CASE SUMMARY
Design Adjustment Committee
DAC-2-924

Design Adjustment
October 16, 2024

<i>Address</i>	4500 Market Street	
<i>Acreage</i>	Approximately 1.39 acres	
<i>Request</i>	Request for design adjustments for driveway offsets and driveway width.	
<i>Consultants/ Agents</i>	Rick Baker 5410 Trinity Road, Suite 102 Raleigh, NC 27607	(919) 532-3262 publiclandpermits@timmons.com
<i>Property Owner</i>	Market Street Ventures, LLC 3013 Hall Waters Drive, Suite A Wilmington, NC 28405	(910) 399-6839 brian.prevatte@wilmingtondevco.com
<i>Design Adjustment Committee Action</i>	9/18/24; Continued 10/16/24; Scheduled for Evidentiary Hearing

Figure 1. Site Plan (Attachment 4)

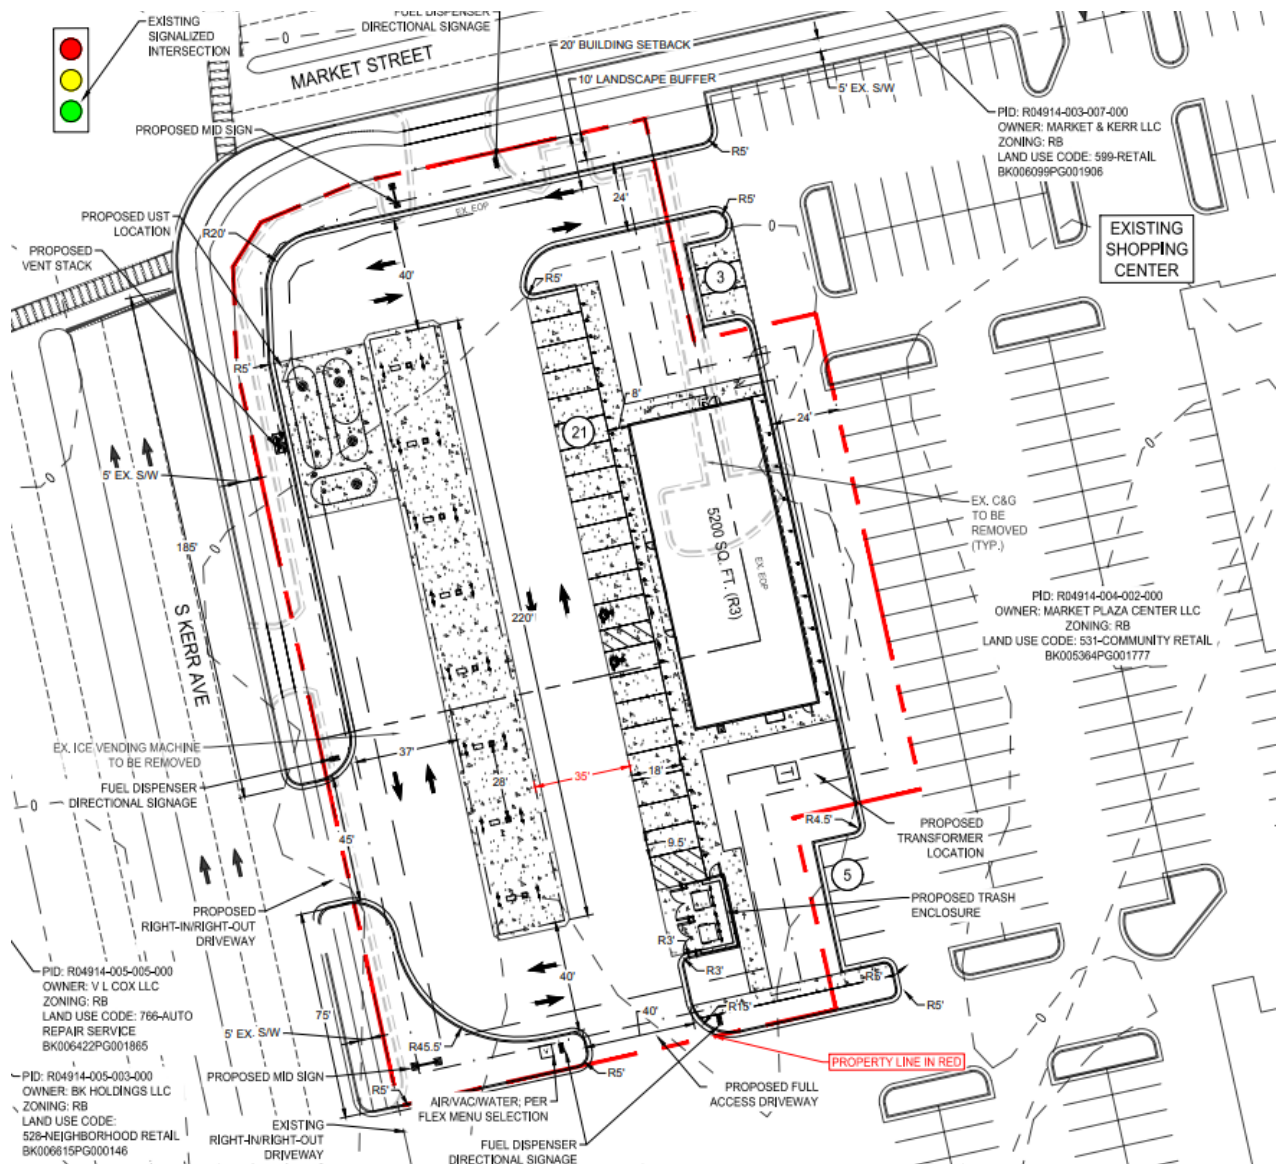
4. A new right-in-right-out driveway access is proposed approximately 185' from the intersection of Market Street and S. Kerr Ave., and 75' feet from the property line to the south.

5. The applicant also proposes a 45-foot-wide driveway instead of the maximum driveway width of 30 feet.
6. The Technical Standards & Specifications (TSSM) specifies minimum standards for driveway clearance (Approved 9/18/24):

- A 2-lane, two-way driveway, which provides access to a Commercial use, has a maximum driveway width of 30 feet, measured at the property line.

Figure 2. Site Plan (Attachment 4- updated for 10/16/24 hearing)

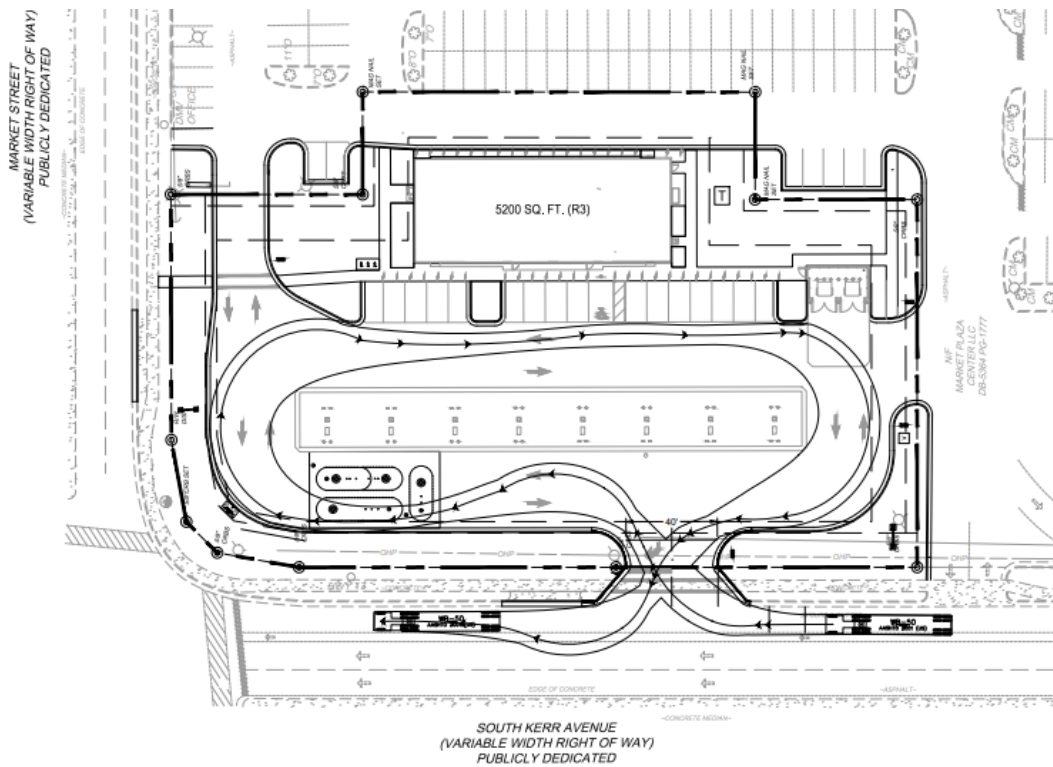
Adjustment	Requirement	Proposed
<p>1</p>	<p>Driveway Clearance: (Approved 9/18/24) a). Required minimum corner clearance of 230 feet along the major thoroughfares and/or 60 feet along all intersecting side streets not classified herein as a major thoroughfare. CH. VII (C)(2)(c)(1) (Page 7-13)</p>	<p>230 feet</p>
	<p>Applicant’s Justification: The purpose of the relief is due to the property being a corner lot fronting Market Street and S Kerr Ave with a frontage of +/- 309’. Meeting a 230’ clearance on the north side towards the intersection and a 75’ offset requirement from the southern property line is not achievable.</p>	
<p>2</p>	<p>Driveway Width: (Updated for the 10/16/24 hearing) a). 30’ maximum width, measured at the property line. CH. VII (C)(1)(b) (Table 3) (Page 7-9)</p>	<p>30 feet</p>
	<p>Applicant’s Justification: The purpose of the relief is due to the nature of the site. A 45-foot-wide driveway is required for safe movements of a WB-50 refueling truck in and out of the site.</p>
